RAMSEY PARKWAY APARTMENTS
 7979 SUNWOOD DRIVE, RAMSEY, MN

SUBMITTALS/REVISIONS
 08/07/2025 SCHEMATIC PAGE FLIP
 08/18/2025 LAND USE APPLICATION

Project: 08/15/2025 10:55 AM W:\2025\250244\CADD\DATA\TITLE_4.dwg Sheet: PLAN L2-1 LANDSCAPE PLAN

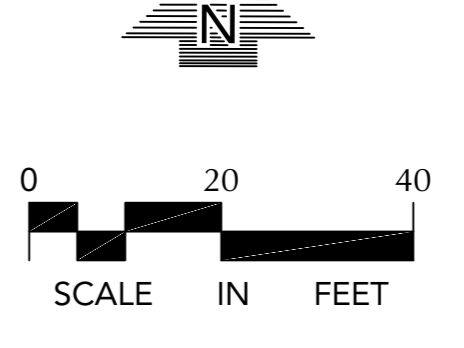
Please update to indicate that this area will be sodded.

Please update to indicate this area will be sodded.

This area is labeled as snow storage on Sheet C2-1. If that's how this area is to be used, it is recommended to not plant any trees here and this maybe should be a different ground cover than the same sod used on the rest of the site (the salt that's likely going to be included in the snow pile will burn out the sod and tree).

Is there enough space between these trees and the building so there is room for them to grow?

Especially in the parking lot islands, but also in those areas with numerous plantings proposed (shrubs and decortive plants), it is recommended to use wood chip mulch rather than rock mulch. There's no ecological benefit with rock mulch and it will make an already very tough growing site that much more inhospitable.

Consider relocating one of the 3 trees just north of this green space into here rather than up against the building.

The slope from the parking lot to the access driveway is nearly a 3:1, which could pose a challenge when mowing the turf. Any way to lessen the slope to make it a bit more manageable for maintenance purposes?

Please include head to head irrigation coverage supplied by the apartment complex within the boulevards and back of curb/sidewalk along Ramsey Parkway and Zeolite Street. City-supplied irrigation already exists within the boulevard along Sunwood Drive. The apartment complex's irrigation should begin at the interior edge of the sidewalk along Sunwood Drive. All irrigation systems must include a rain sensor and some form of water efficient technology, such as a weather compensating smart controller.

Please specify that minimum shrub size at installation is 24" in height.

Please add the following note to this sheet:

Four (4) inches of topsoil is required over all disturbed areas not otherwise improved with impervious surfacing. Topsoil shall not have more than 35% sand content. A topsoil inspection is required prior to installing landscaping (sod, trees, shrubs, etc.).

Please include a planting detail for the trees/shrubs. For trees, planting depth is critical and the detail shall specify that the first set of primary roots shall be at finished grade level.
